IO GEV CORNELL
SYNCHROTRON LABORATORY
CORNELL UNIVERSITY
ITHACA NEW YORK

POWER
SINGLE LINE DIAGRAM
SHEET 1 OF 2

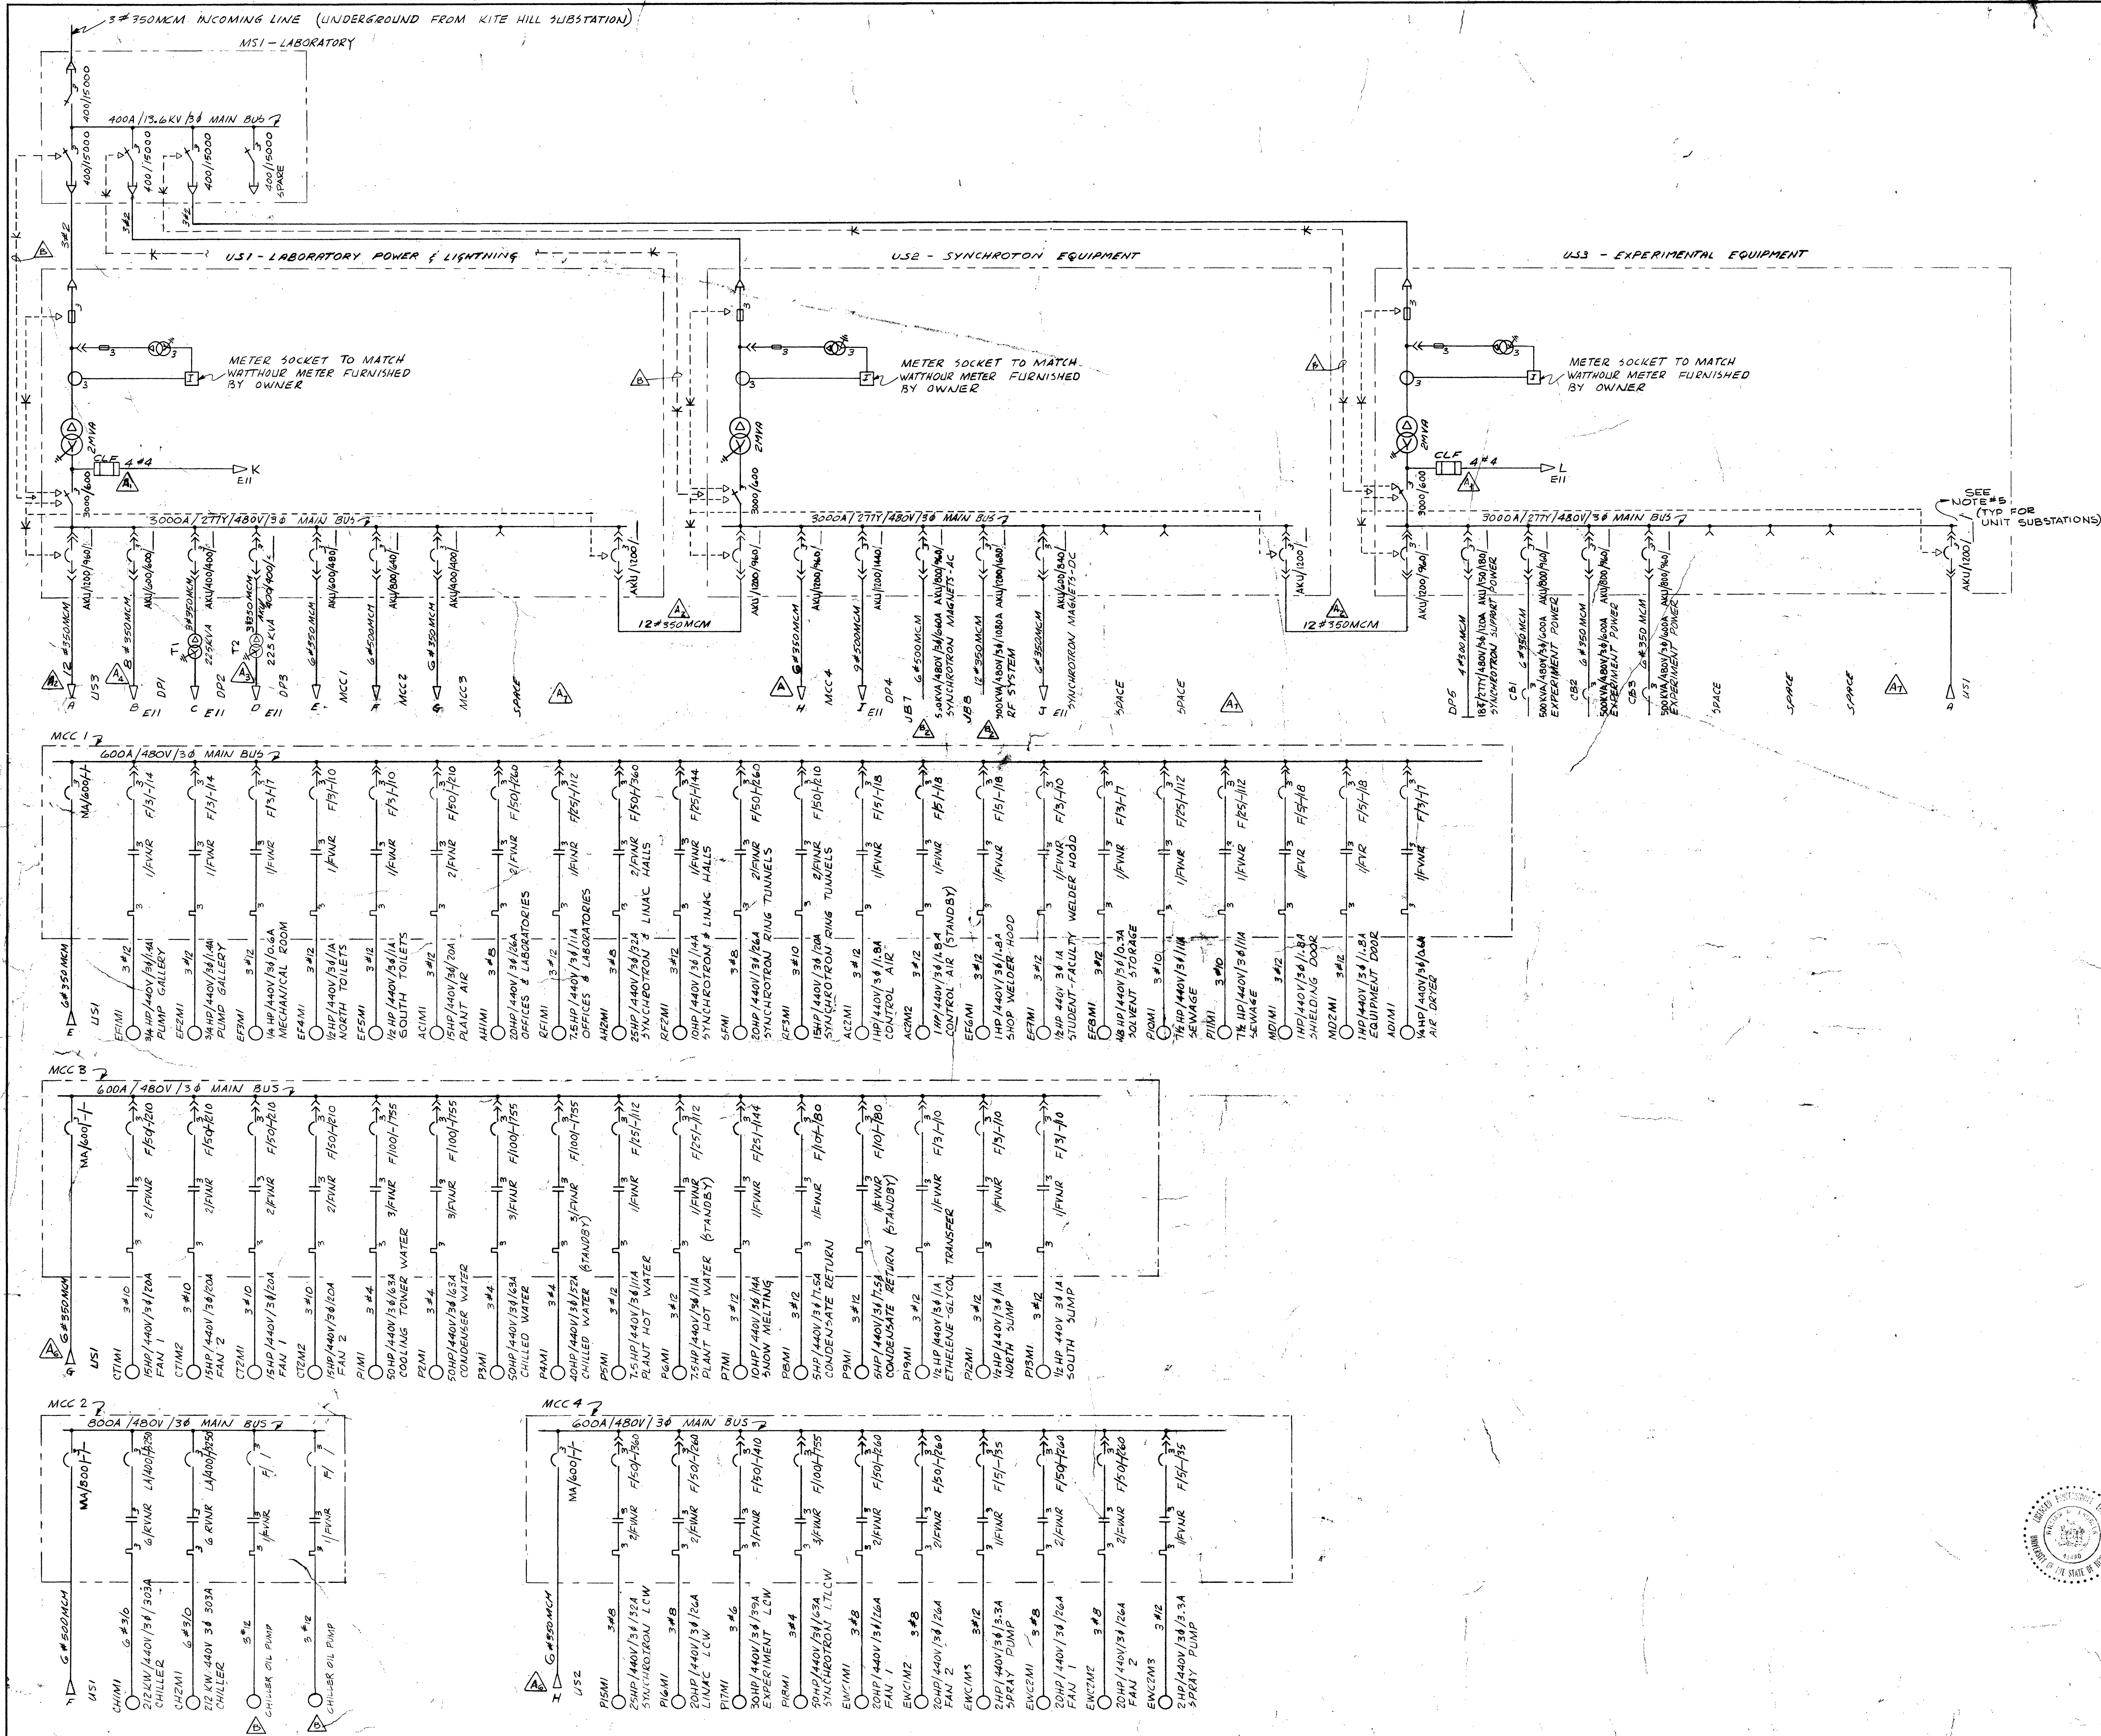
AS-BUILT CORRECTIONS	1-20-61	RPE
1) ADDED FUSES FOR EMERGENCY CIRCUITS		
2) BUS TIES CHG. FROM 9" #350 MCM		
3) US1-D CHG FROM 6" #350 MCM TO 6" #350 MCM		
4) US1-B CHG FROM 6" #350 MCM TO 6" #350 MCM		
5) ADDED NOTE #5		
6) REVISED TO CONFORM WITH E-14		
7) DELETED 1 SPACE FROM US1 & US2 & US3		
LTR	REVISIONS	DATE
	BY	APPD
